REQUEST FOR INFORMATION **DATE:** July 07, 2017 **NO.:** RFI-586

Project Name: 15051-Webster University Interdisciplinary Science Building Project No.: 15051

Subject: Mounting Height and location of Steris OR Light Switch

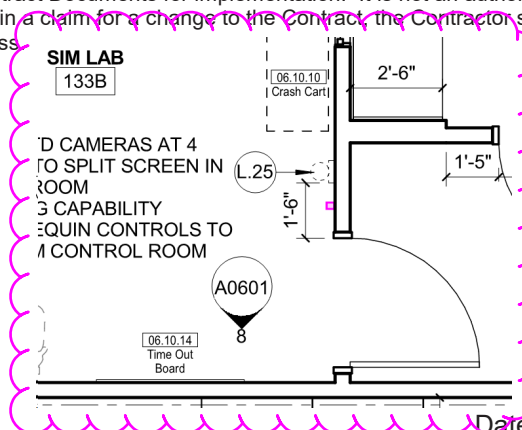
Please provide the Mounting Heights and locations of the Steris Light Switch... There is a special rough in associated with the Steris OR Light and it is not shown on the plans.

PER OWNER'S DIRECTION, LOCATE SWITCH AT LOCATION MARKED IN THE SKETCH BELOW AT 48" ABOVE FINISHED FLOOR.
